UNITED STATES PATENT AND TRADEMARK OFFICE

APPLICATION NO.	FILING DATE	FIRST NAMED INVENTOR	ATTORNEY DOCKET NO.	CONFIRMATION NO.
10/773,818	02/06/2004	Teruhisa Shibahara	36856.1213	7932

Office Action Summary	Application No.	Applicant(s)	
	10/773,818	SHIBAHARA ET AL.	
	Examiner	Art Unit	
	Barbara Summons	2817

DETAILED ACTION

【図1】

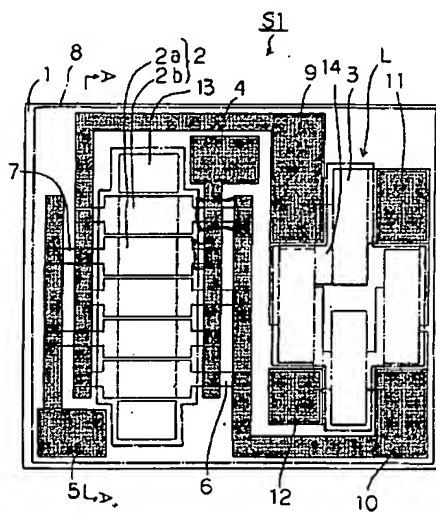
Regarding claims 1-3, 6 and 7, Fig. 1 of Matsuda discloses a SAW filter comprising: a piezoelectric substrate 1 that is lithium tantalate or lithium niobate (see section [0018] of the attachment 1 machine translation) each of which has the inherent material property of a relative permittivity greater than 20 (see e.g. Takeno applied below as evidence); an insulating pattern 8 disposed on the piezoelectric substrate and being silicon dioxide (see section [0021] of the translation) that has the inherent material property of a relative permittivity that is less than that of the piezoelectric substrate and that is about 4 or less; and a conductor pattern shown in Fig. 4 that has a first conductor pattern that defines input/output IDTs 2a and 2b of the IIDT filter 2 and is disposed on the piezoelectric substrate where the insulating layer is not (see Fig. 3), and a second conductor pattern that defines signal wiring traces 6 that connect to lattice filter L (Fig. 1) and the shorter ground wiring traces between them (i.e. connected to ground 4 in Fig. 1) that are in conduction with the first conductor pattern IDTs, and wherein at the portion where the wiring traces 6 and the short ground wires between them (as best seen in Fig. 4) being of different potentials and arranged in parallel and face each other in plan view, these wiring traces are all disposed on the insulating pattern 8 as can be seen in Fig. 3. Regarding claims 8 and 9, see section [0025] and section [0033] of the translation. Regarding claim 12, see section [0001] of the translation. Attachment 1

has been included with a red box drawn around the areas that the Examiner is using as locations where the parallel lines of different potentials and facing each other in plan view, overlie the insulating pattern 8.

Applicants argue that "the element 6 of Matsuda...is disposed on and electrically connected to the wiring pattern 9...not on an insulating pattern" (see page 6, the last para. thereof of the amend.). This argument is not persuasive for several reasons. Firstly, the Examiner did not use the wiring pattern 6 on the left side of the IDTs 2a,2b, but used the pattern 6 on the right side just to be sure to have different potentials because the lines connected to 4 are ground (note that the machine translation section [0020] provided with the prior Office action is a bit muddy on which patterns, those connected to 4 or 5, are grounded). However the wiring patterns on the left and right sides of the device are similar, so either side could be used. Secondly, Applicants use Fig. 5, which is a cut through at line A-A in Fig. 1 and is directly through the via holes in the insulating layer 8 (best seen in Fig. 3), but there are other portions of wiring lines 6

and the short lines therebetween (see the portions in the red boxes outlined in Figs. 1, 3 and 4 of Matsuda on the attachment 1 provided) that do lie on top of the insulating pattern on either side of the filter. There is nothing in the claims requiring that the entire area of the wiring lines must be on the insulating pattern, and as explicitly stated by the reference "electrode extension sections 6 and 7 of the IIDT electrode 2... are arranged on the insulating layer 8" (see the translation section [0016], the last three lines thereof). Therefore, the argument is unpersuasive and the rejection has been maintained.
